Museum of Danish Resistance 1940-45

Restricted design competition, Copenhagen

Assessment panel report, May 2015

Plan 01

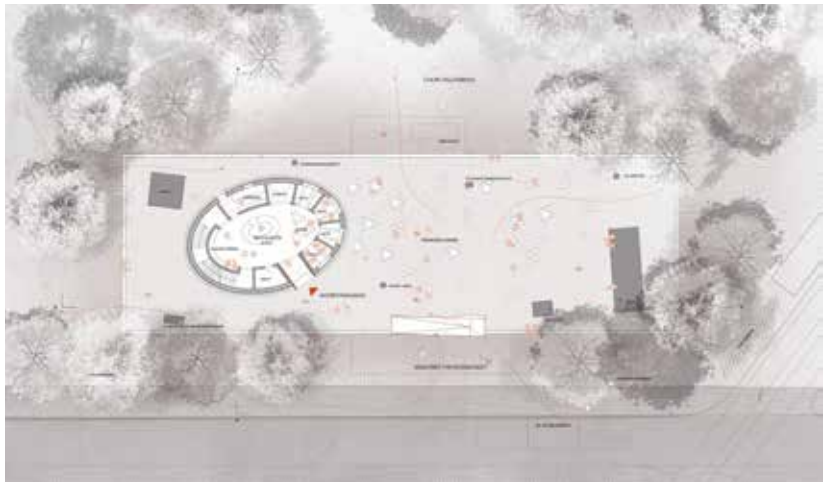
Ankomstbygningen har hovedindgang mod Esplanaden. Der er info, butik og café på dette indgangsniveau samt adgangsforhold til et øvre dæk, hvor der er flexrum, et panoramavindue samt personalefaciliteter. Trods ankomstbygningens beskedne størrelse tilvejebringes de funktioner der fordres, men det er dommerkomiteens vurdering, at indretningen har logistiske udfordringer. Flexrummet på plan +1 forekommer meget anvendeligt, men skal kunne betjenes fra café/køkken. Trappeforbindelserne gennem de forskellige etager virker som logiske og enkle forløb. Mellemetagen plan -1 med orienteringsområde, toiletter, garderobe mm. er løst på en enkel og naturlig måde. Herfra vil der være forbindelse til eksisterende kælder, som foreslås anvendt til særudstillinger.

Plan -2

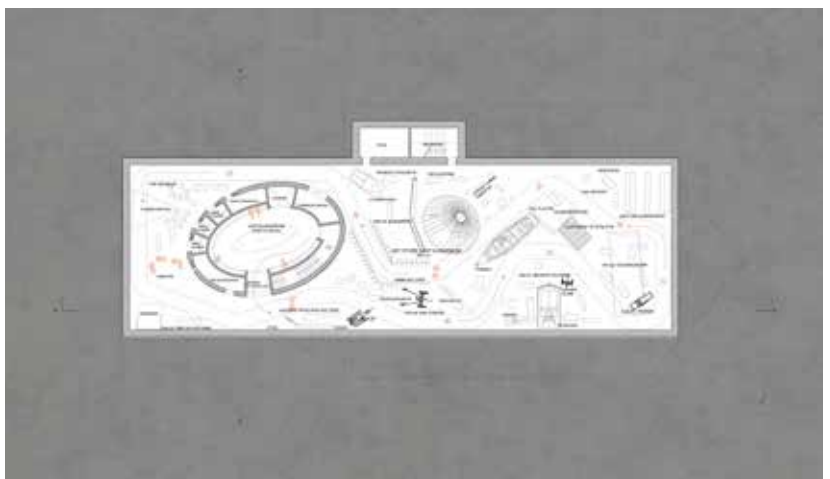
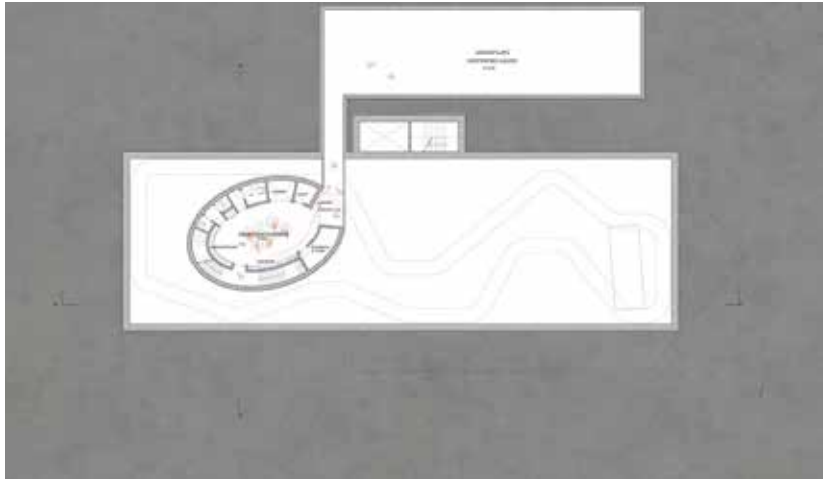
Plan -2 indeholder et udstillingsrum i selve rotunden samt et birum. Herfra træder man ud i en højloftet udstillingssal, der udnytter det meste af byggefeltet. Loftshøjden er her ca. 6 meter. Den store udstillingssal i plan -2 foreslås som en rå ramme, og her kan man fokusere på del og helhed i scenografi og fortællinger. Der er intet dagslys i udstillingsområdet.

Den viste elevator skal efter dommerkomiteens vurdering dimensioneres, så den kan klare grupper og genstande. I forslaget er vist, at transport af store og tunge udstillingsgenstande skal ske ved at åbne et dæksel i loftet over udstillingsrummet. Dette vurderer dommerkomiteen er en tilfredsstillende løsning, forudsat at der vil være den fornødne sikring mod indbrud og vandindtrængning.

Disponering af eksisterende kælder skal overvejes nærmere. Nationalmuseet vurderer, at kælderen er uegnet til særudstillinger.
